工程指示 / 要求簡箋(E.I.)

工程指示編號：EI / 5272 / 22

工程名稱：將軍澳日出康城 LP 11

工程項目：幕牆 大貨單元件加工圖

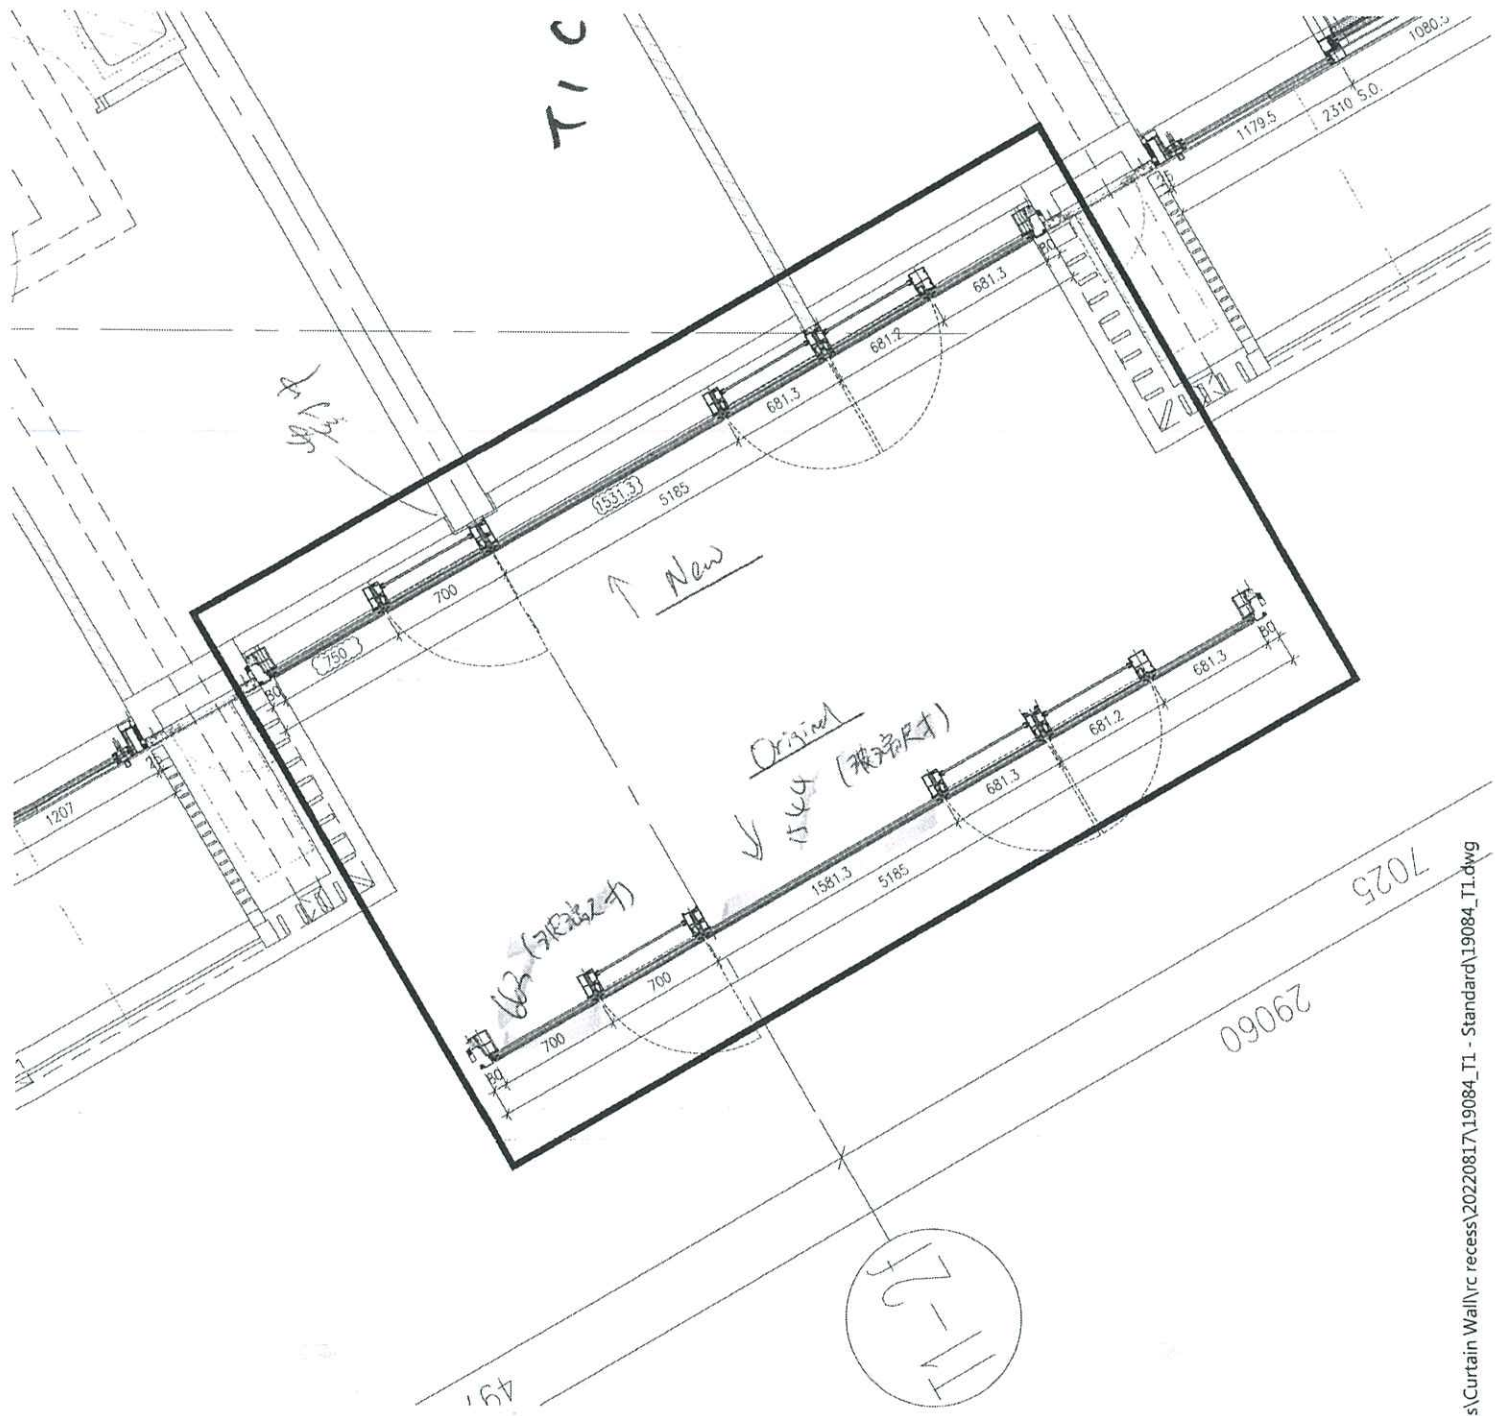
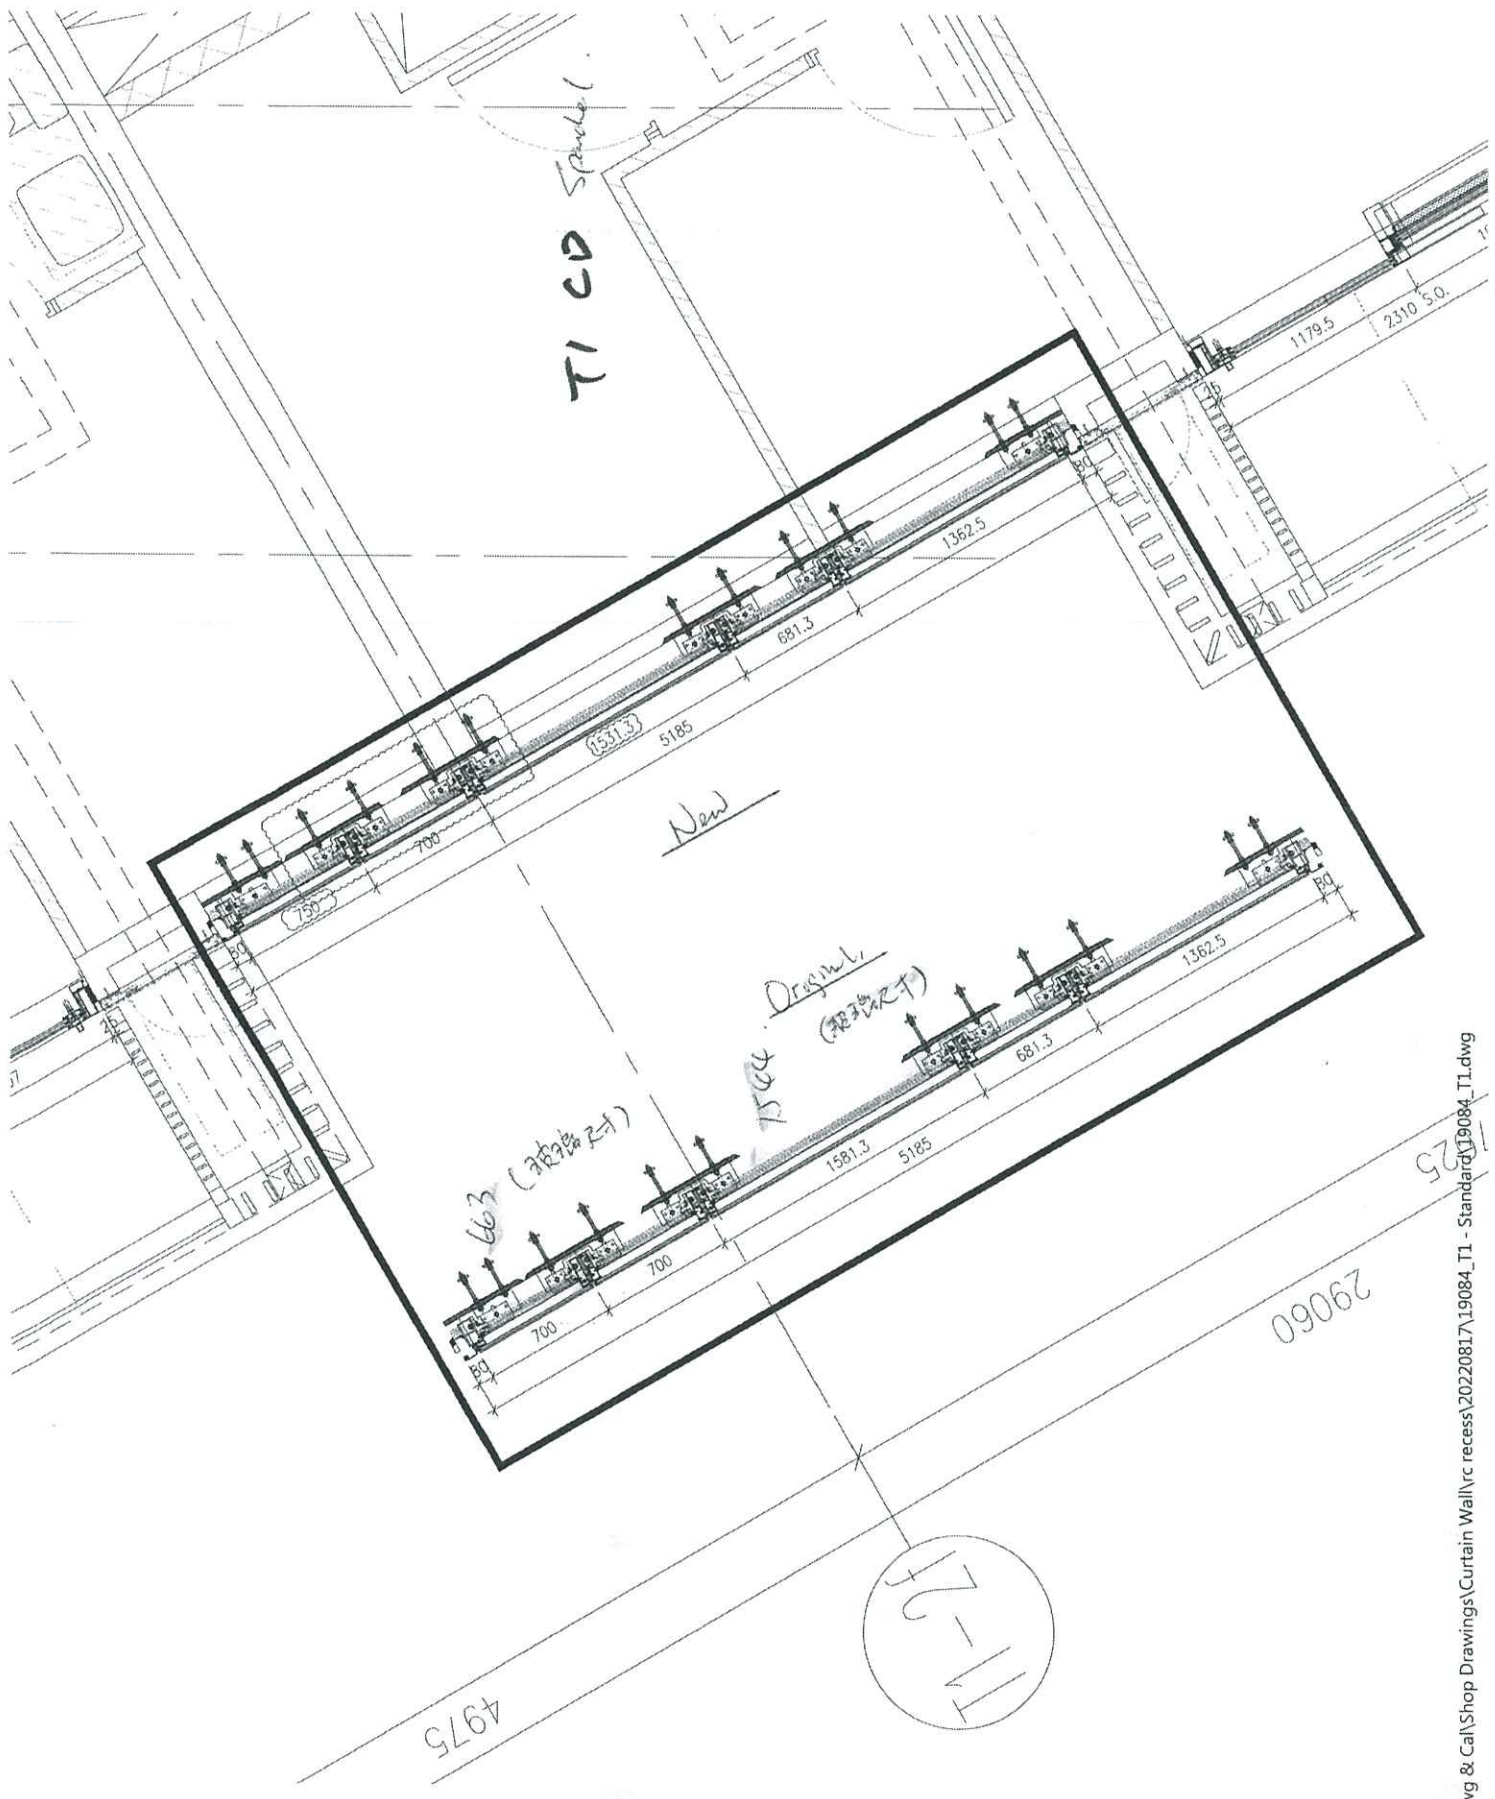
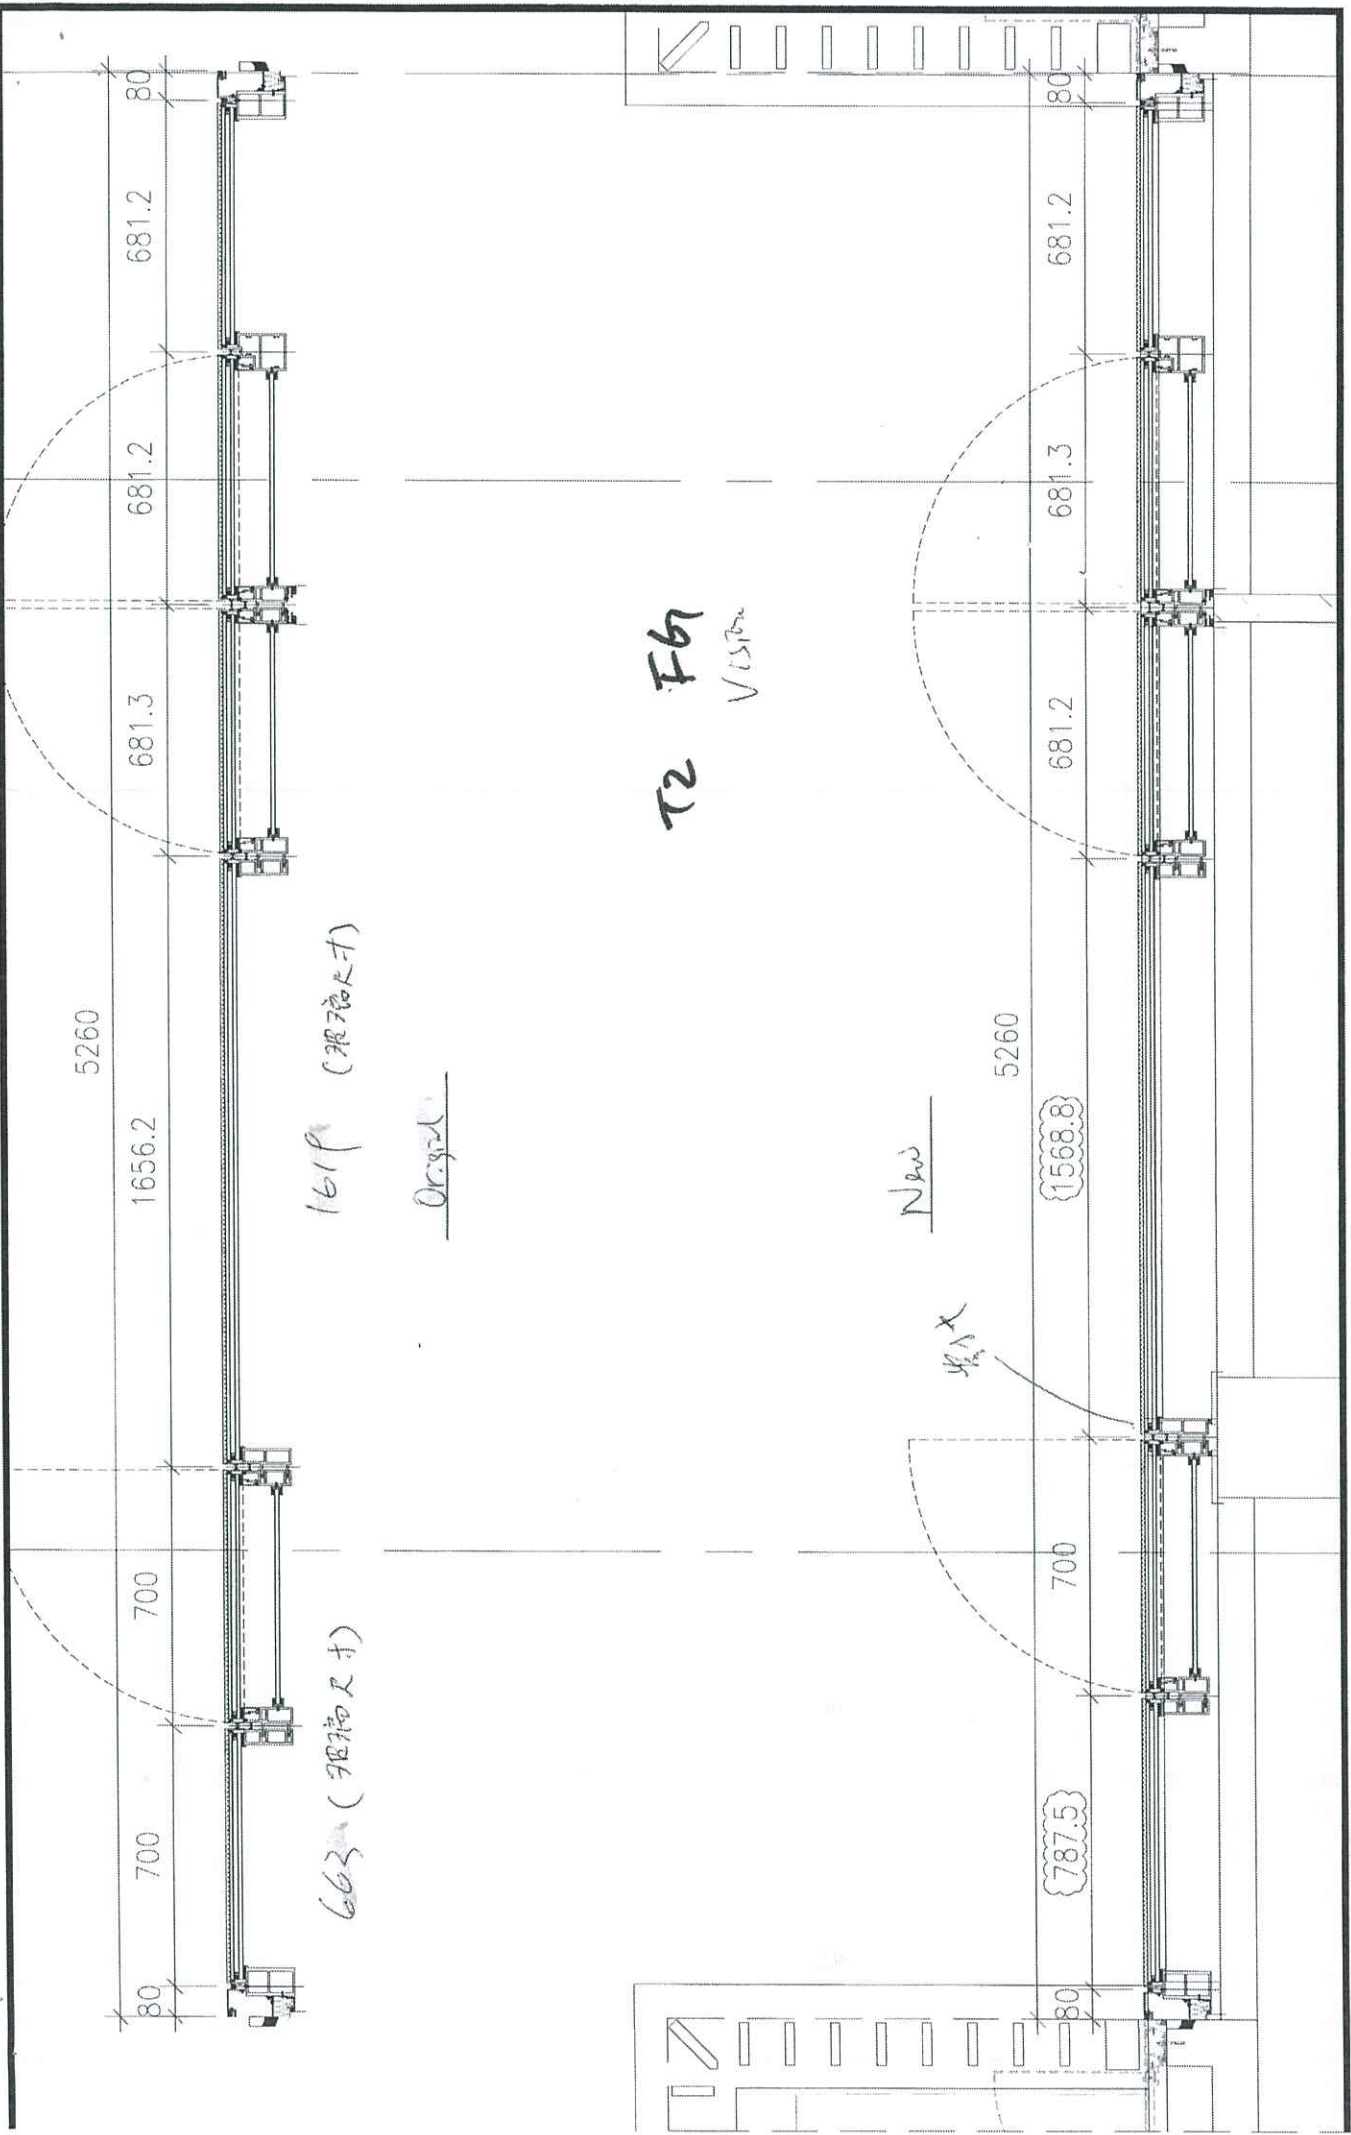
Original

New

修改
